April 22, 2025

**ADDENDUM NO. 5
TO THE
CONTRACT DOCUMENTS
FOR
CONVENIENCE CENTER & RECYCLING FACILITY CONSTRUCTION
ASSEMBLY COURT SOLID WASTE CONVENIENCE CENTER &
PARKTON SOLID WASTE CONVENIENCE CENTER**

BID ISSUE DATED MARCH 2025

Assembly Court "Existing Ground" vs. Proposed Finished Grade

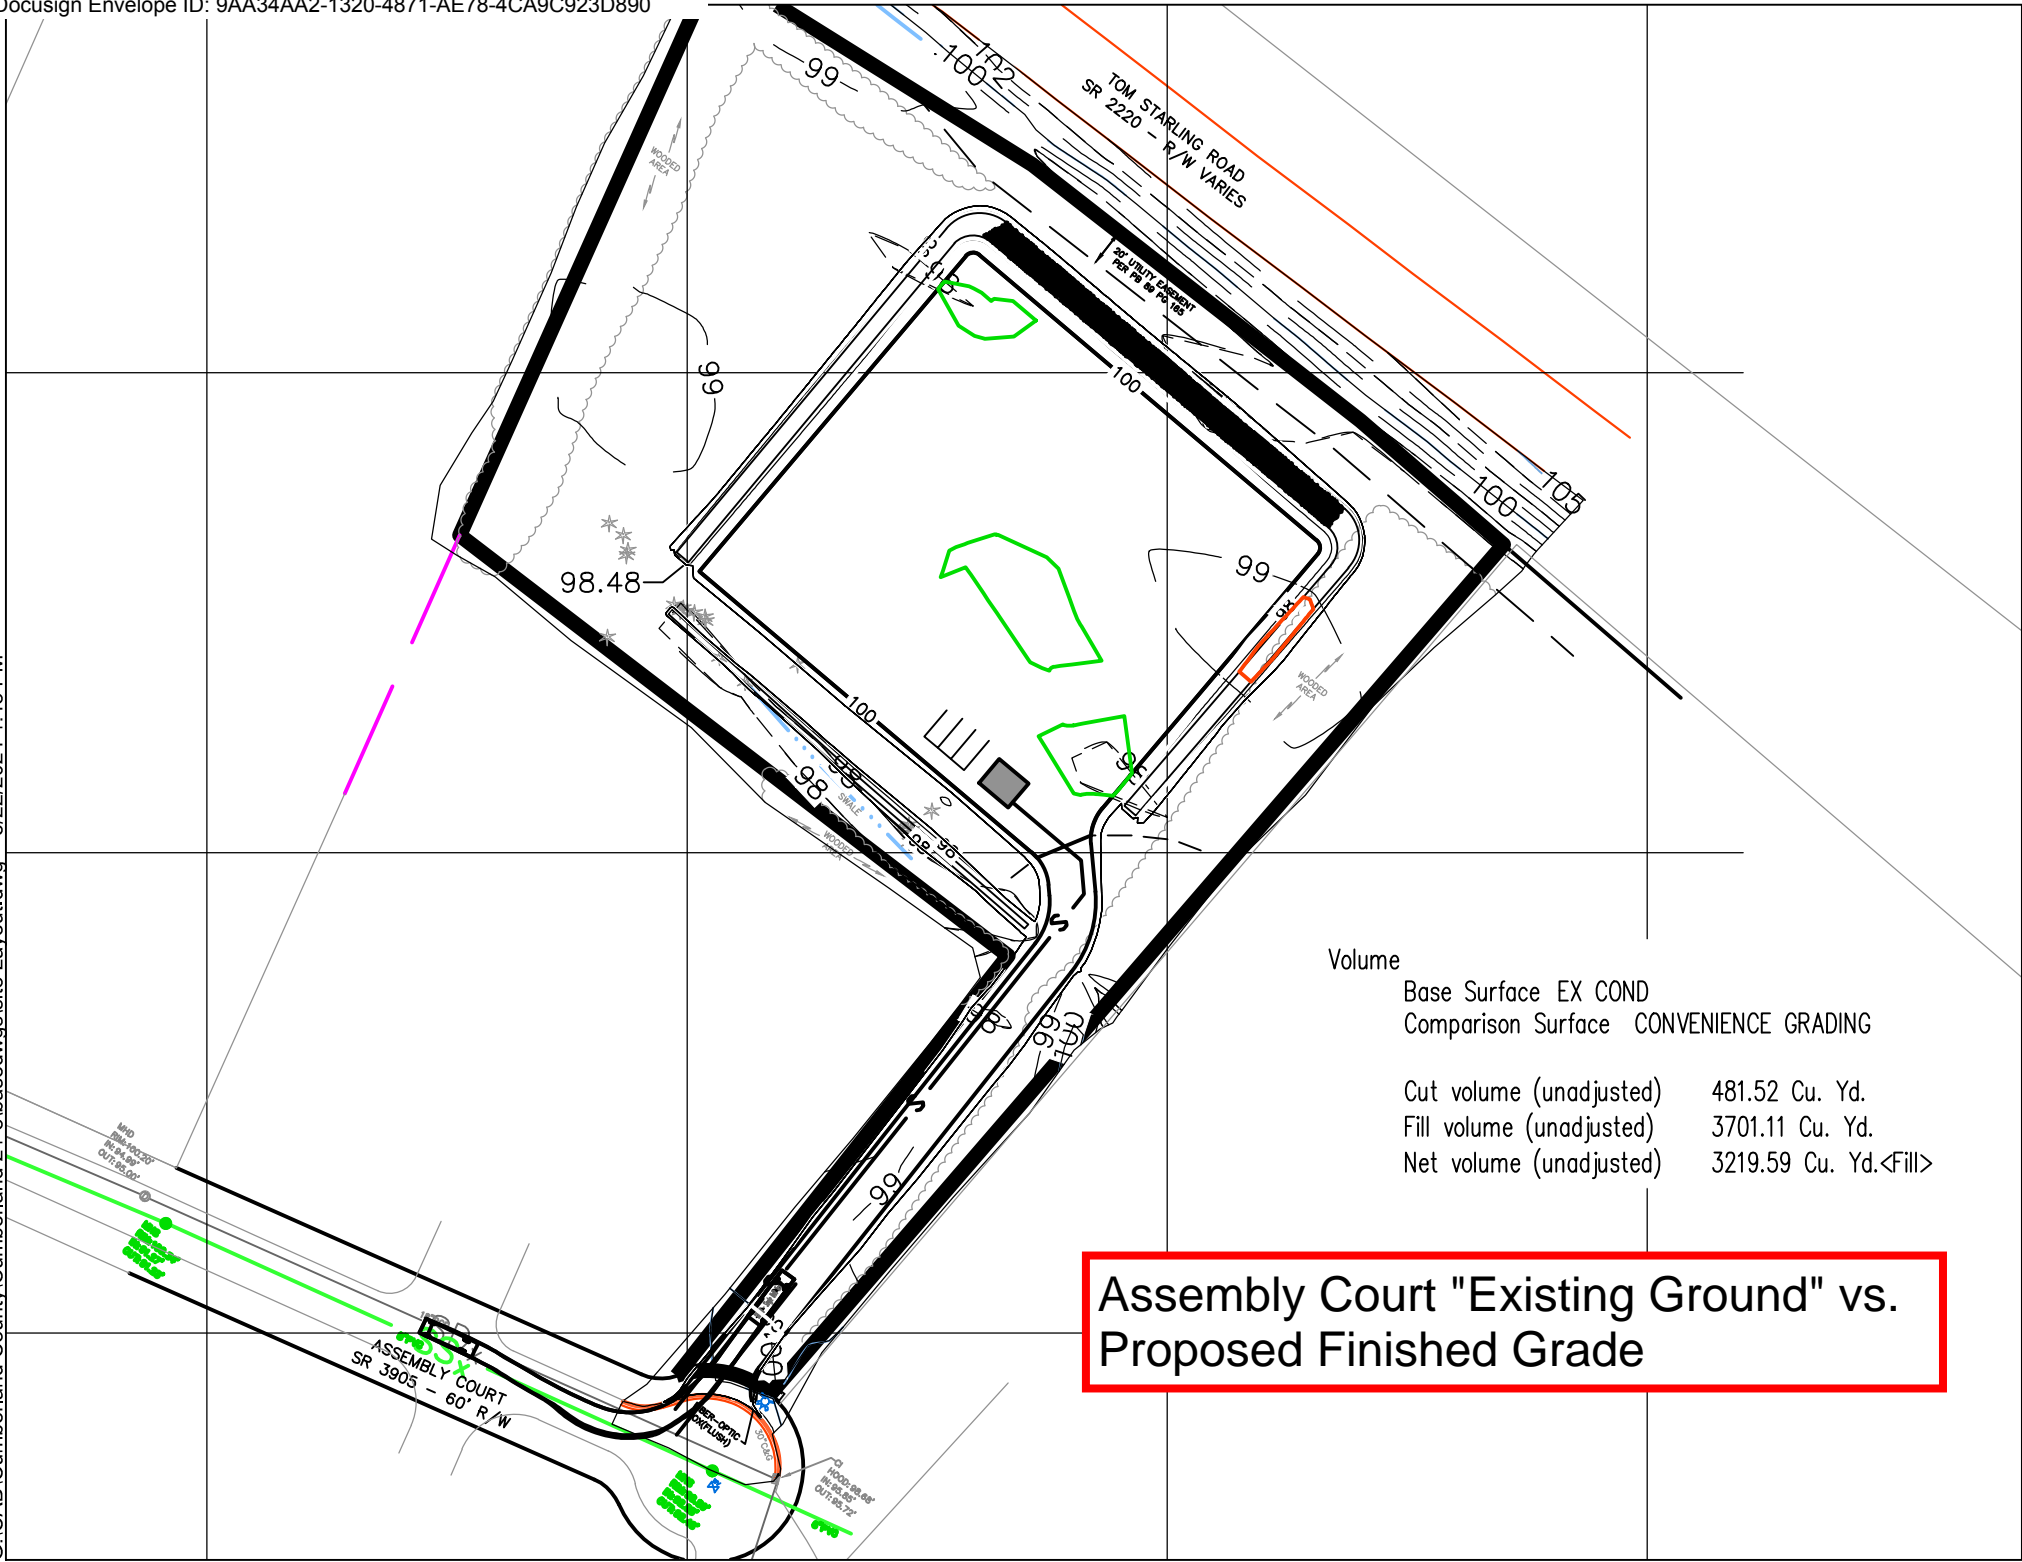
1. Do the volumes noted include the additional cut that may be needed to cut to subgrade for the differing pavement designs or is this additional cut that will need to be allowed for?

*Volume isopachs for both sites comparing existing ground to finished grade are **attached** to this submittal for reference.*

Volume for embankment at Assembly Court represents embankment to subgrade. The embankment volume has been adjusted in the base bid schedule to account for the volume required for paving and aggregate surfacing to reach finished grade.
